# NORTHEAST UTILITIES

Millstone Nuclear Power Station, Unit No. 3  
Response to Materials Engineering Branch DSER Open Items

Millstone Nuclear Power Station, Unit No. 3

MTEB 251.1 Appendix G and H, 10CFR50 (Draft SER Section 5.3.2)

FIGURE 5

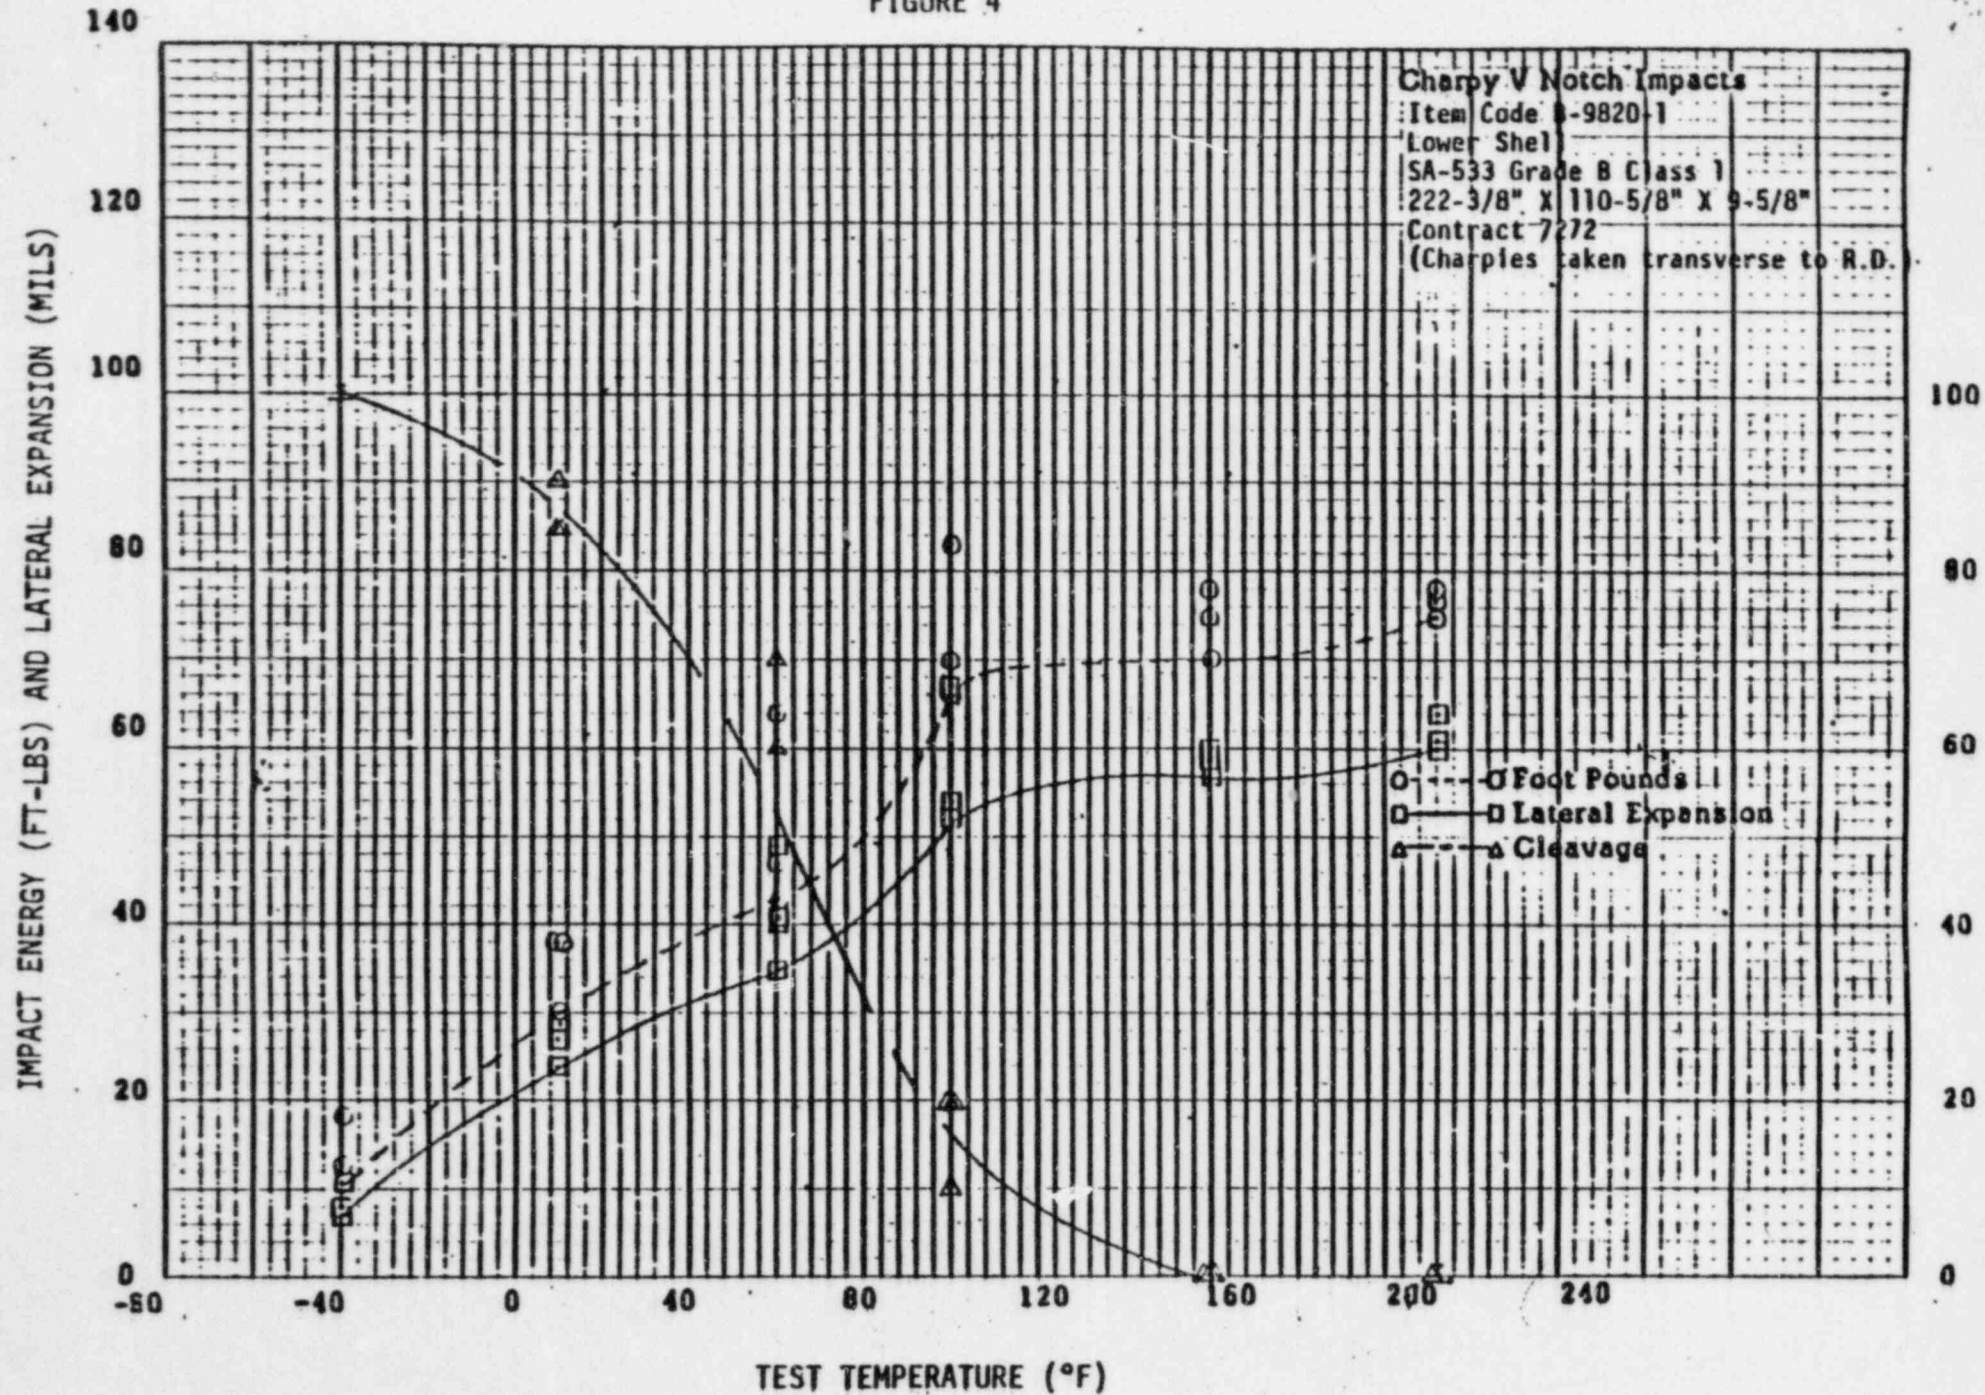
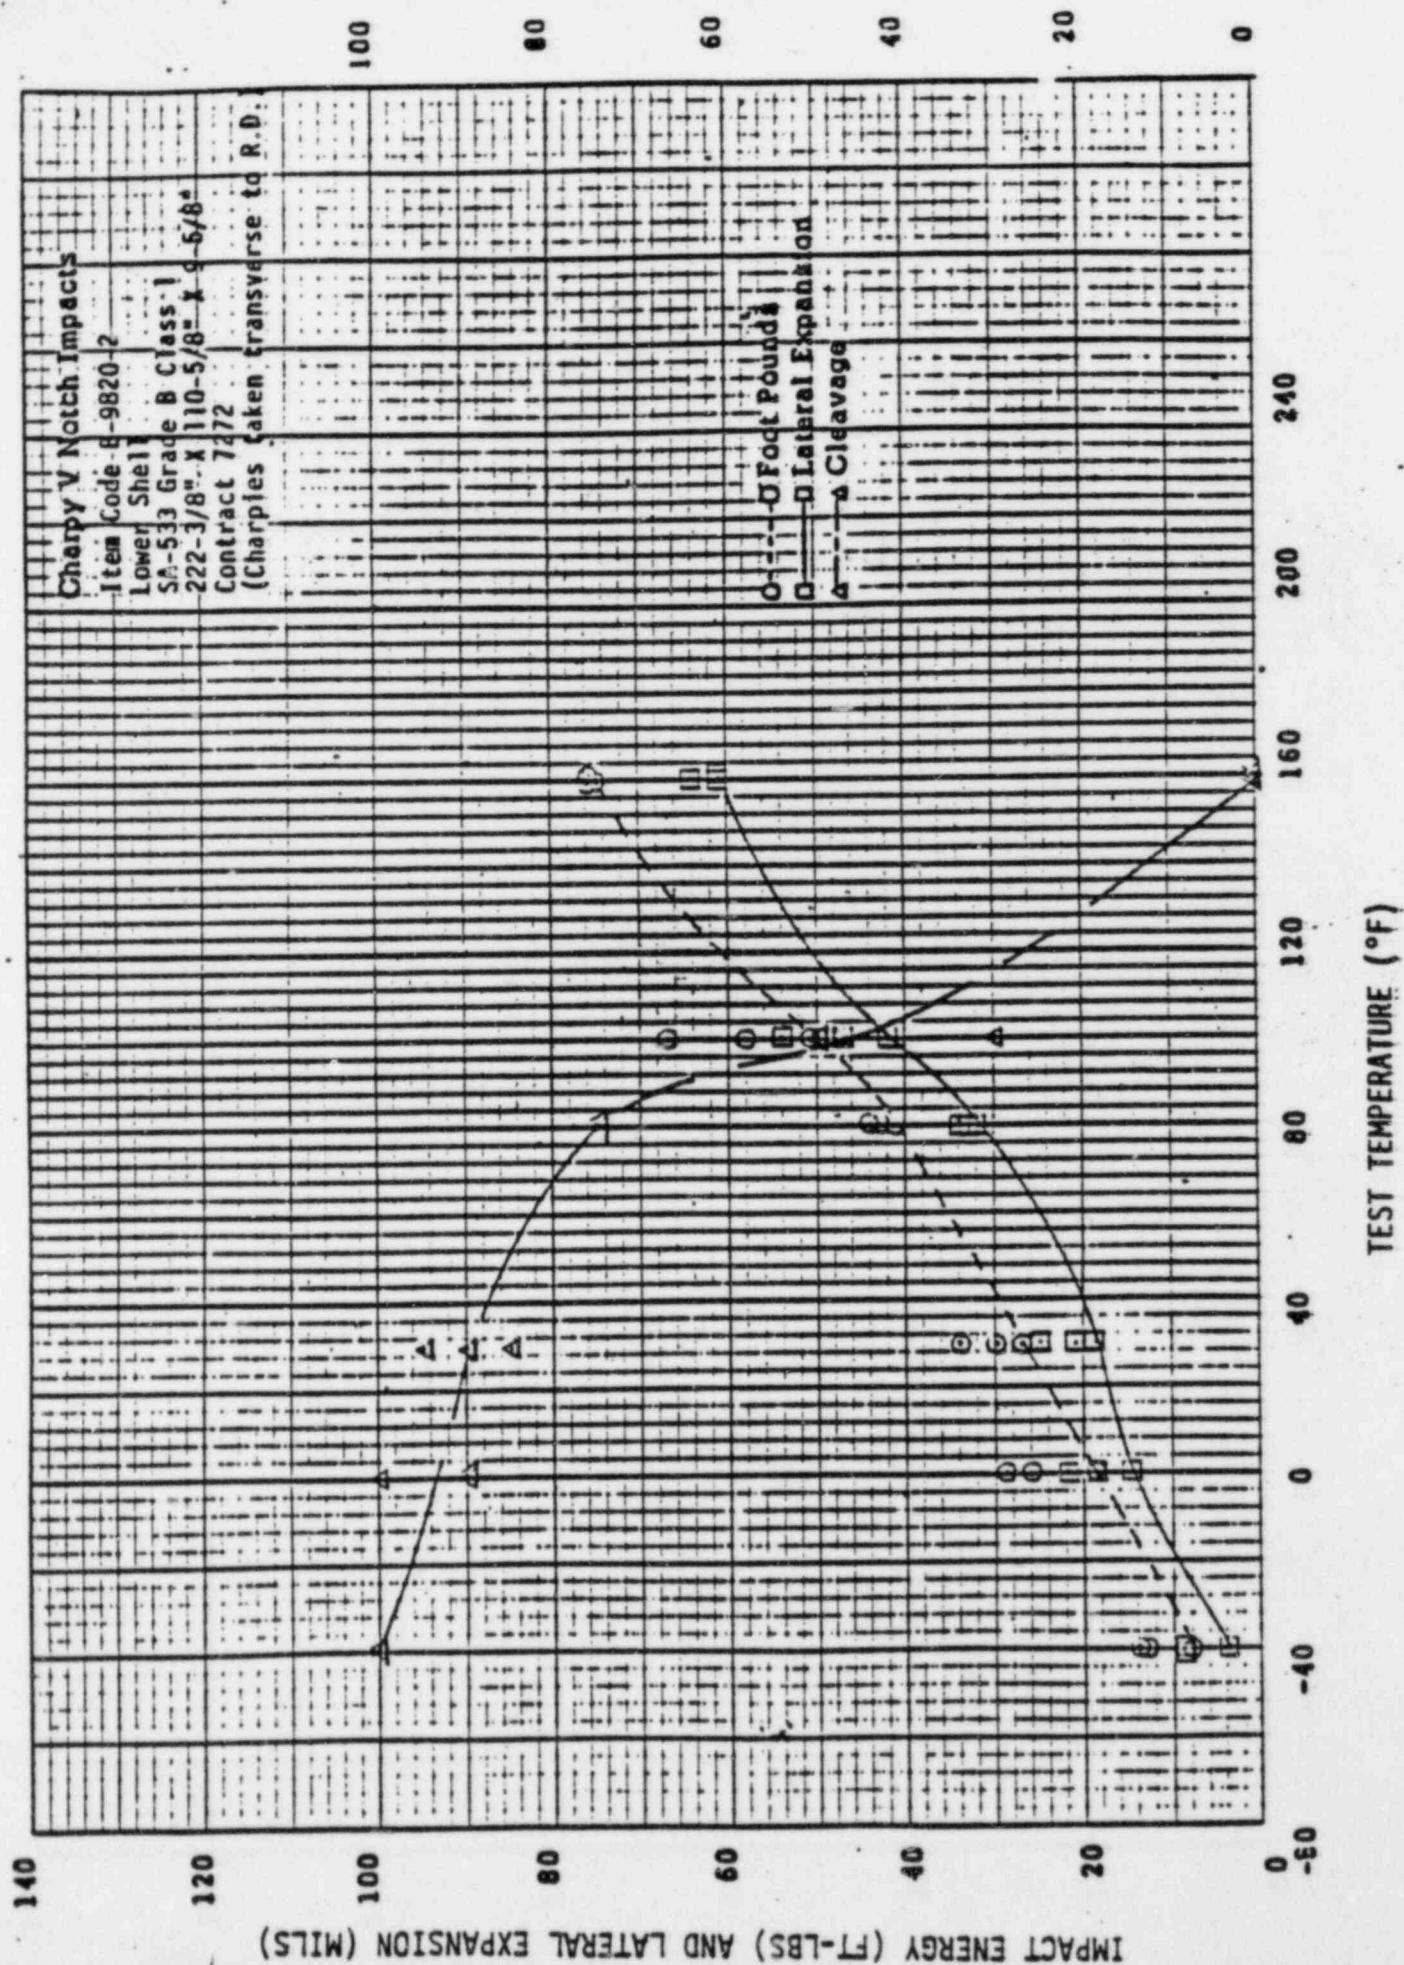
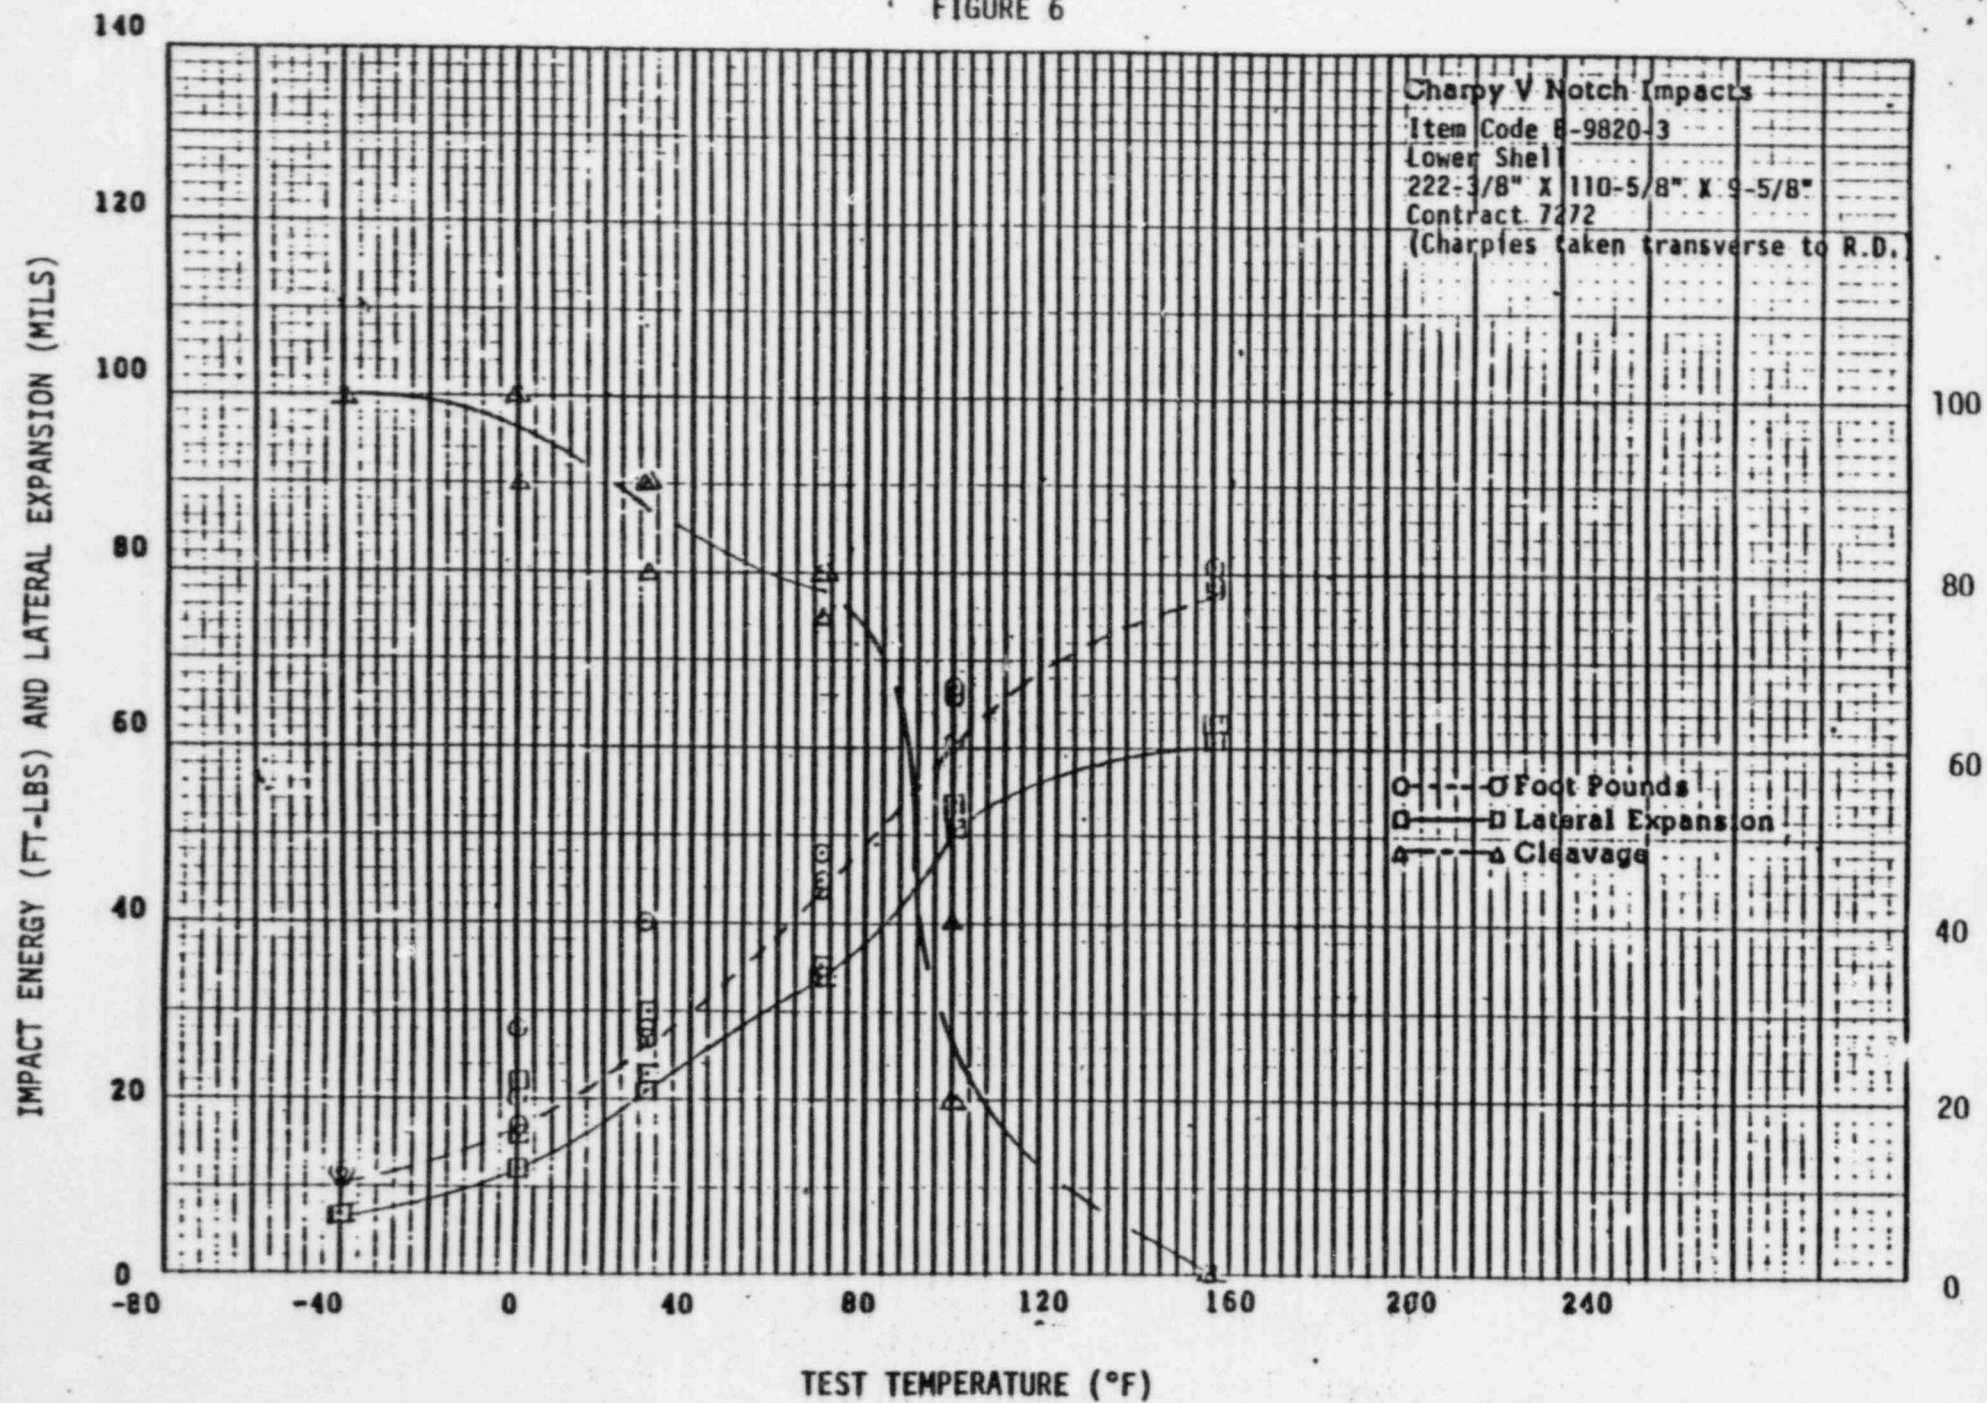
- a. Provide full Charpy V-notch curves for the reactor beltline materials. The curves should be in terms of fracture energy (ft-lbs) and lateral expansion (mils) versus test temperature (°F).
- b. Indicate the base and weld materials in the surveillance capsules. The identification should include the following:
  - (1) Chemical composition
  - (2) Heat treatment
  - (3) Plate number for base materials and weld control number for weld materials.
- c. Indicate the lead factors for all the surveillance capsules and their azimuthal positions within the reactor pressure vessel.
- d. Provide technical justification for the surveillance capsule withdrawal schedule as outlined in Section 5.3.1.6 of the Millstone Nuclear Power Station, Unit No. 3 FSAR.
- e. Provide pressure-temperature limits for the Millstone Nuclear Power Station, Unit No. 3 reactor vessel.

- Part (a) Please find attached (Figures 1 through 7) the Charpy V-notch curves for the Millstone Unit No. 3 reactor beltline materials. These curves originate from Combustion Engineering test data.
- (b) Intermediate shell plate B9805-1, Lukens heat no. C4039-2 is the surveillance base material. The chemical composition (C-E analysis) and heat treatment of plate B9805-1 is given in Table 1.
